**Service Bulletin**

**No. :** MZ03-022

**Model:** SR7300

**Subject:** The output of Subwoofer is delayed.

#### Download Firmware for CPU (Mode 2)

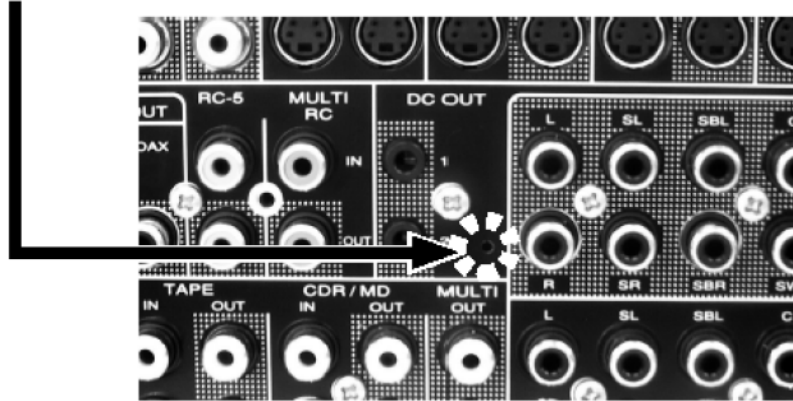
**Symptom:** When playing the DVD, The output of Subwoofer takes about 10 seconds to change from STOP to PLAY.

1. Update the CPU (QU01) firmware version to "V030502\_1 "
2. Please refer to the service manual SR7300/SR7300F/PS7300 page 53 for details about "10.UPDATE FIRMWARE" "Download Firmware for CPU (Mode2).
3. Update the firmware. (file name: SR7300\_H8\_030502\_1.zip)

1. Put the "CPU upgrade" folder into anywhere on your PC's hard disc.
2. Connect PC and the unit with the RS-232C cable.
3. Insert a thin rot to the hole and push the switch (SA50) inside to turn on the switch.
